Prep changes are as follows:

Yale School Street, Willenhall, West Midlands, WV13 3PW T: 01902 366800 www.yaledws.co.uk Prep rev. 6

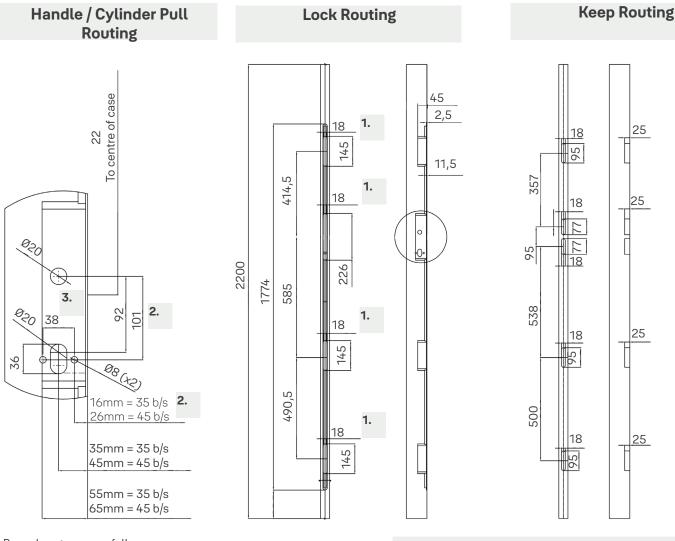
- 1. Pocket prep opened to 18mm to reduce the chance of pinching around the locking units and to allow for better centralisation of the lock within the door slab
- 2. Dimension added (101mm) from Spindle centre line to centre of fixing screw this is crucial when fitting the cylinder pull. Note: this is a critical dimension
- **3.** Recommended Cylinder Pull fixing screw dimension (38mm) added
- 4. Required Eurogroove depth added

Note: If a 16mm faceplate lock is being used without a carrier please refer to Yale Technical Services team.
